## **Appendix S: Response to Comments**

### **For Programmatic Environmental Impact Statement on Utility-Scale Solar Energy Facilities in Washington State**

Washington State Department of Ecology

June 2025, Publication 25-06-002

*Figure 1: High Benefit, Low Harm Land Available for Siting Solar Systems (Bozuwa, Mulvaney, Estevez, Karlsson, and Malhotra, 2024)*

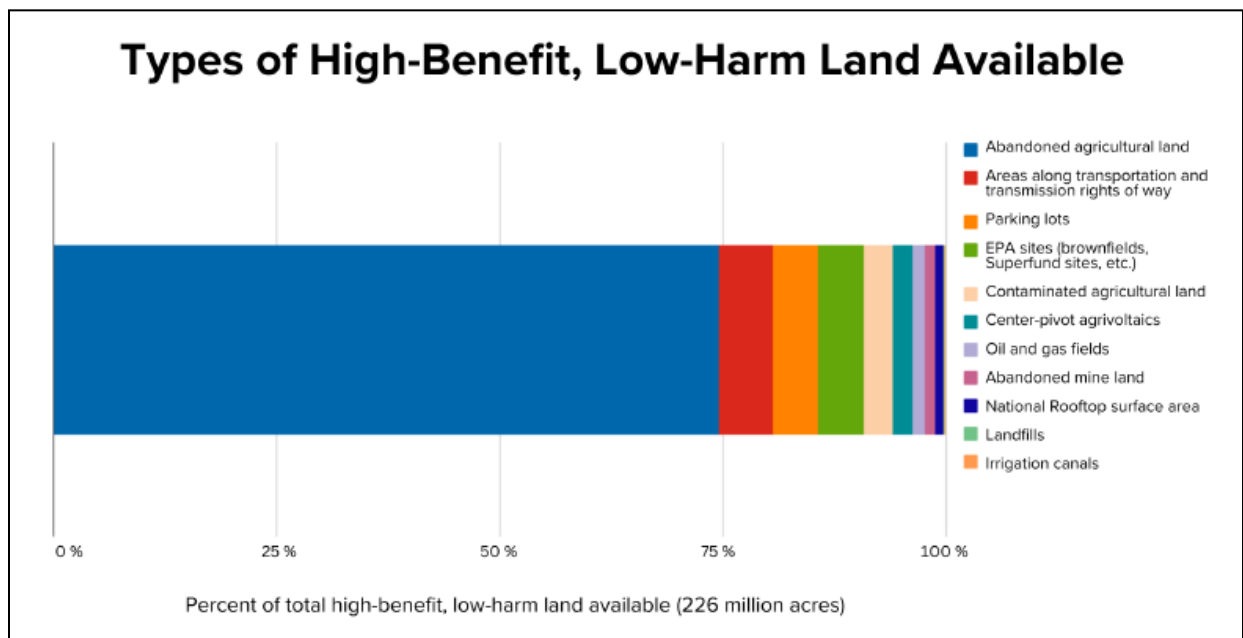
- 7 Adding solar panels to existing structures, like parking garages, warehouses, government buildings, shopping malls, and the like, also can feed electrons to the grid without taking valuable farm or ranch land out of production. Additionally, installing solar near the high demand areas of western Washington will reduce the need for costly upgrades to and energy losses associated with transmission lines across the Cascade Mountains. Indeed, in “Planning to Build Faster: A Solar Energy Case Study,” researchers from the Climate and Community Institute of the Roosevelt Institute recommend siting solar on abandoned agricultural lands, existing rights-of-way, parking lots, superfund sites, and the like, as shown in the figure below.<sup>9</sup>

*Figure 2: Relative Environmental Conservation Value of Lands on the Columbia Plateau (Washington State University Energy Program, 2023)*

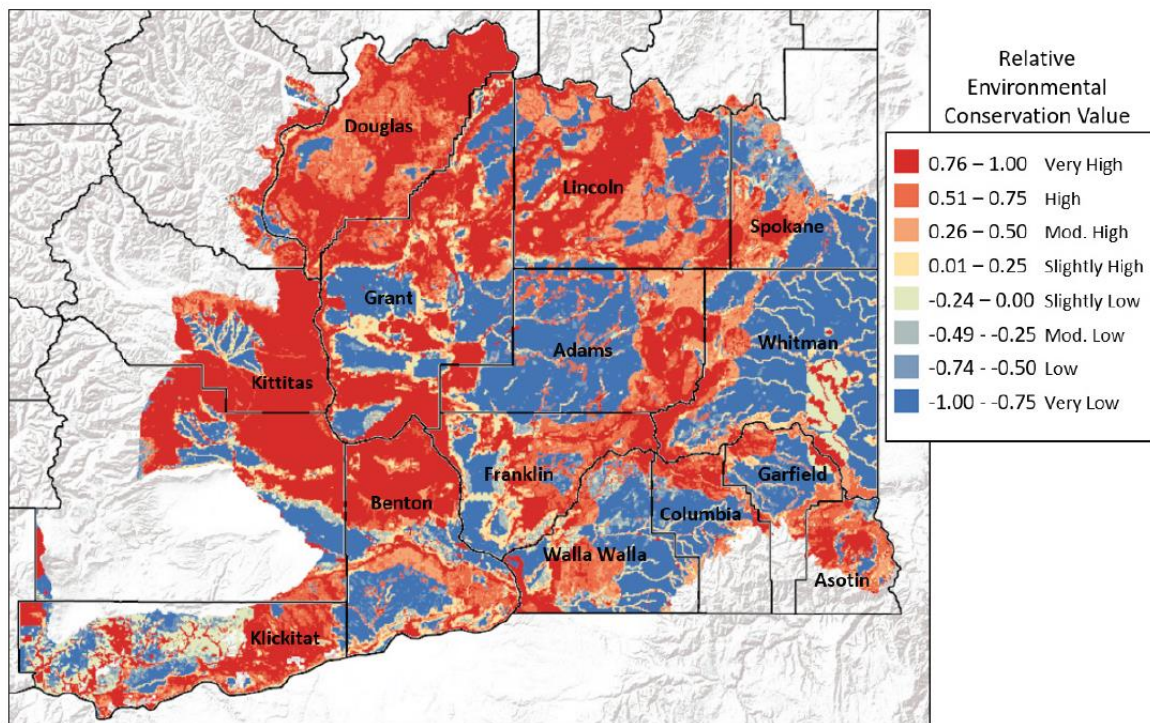
The Least Conflict Solar Siting Report and associated gateway provide similar maps for values of ranch and farmland, and a composite map that combines solar insolation information with data from the other maps. The gateway tool can also identify areas not used by wildlife, of low conservation value, not considered prime farm or ranchland, and thus more amenable to development for utility-scale solar. The information contained in the Report and gateway tool provide a more nuanced picture of the potential impact of utility-scale solar on the natural resources of Washington than the current PEIS and should be incorporated into the final PEIS.
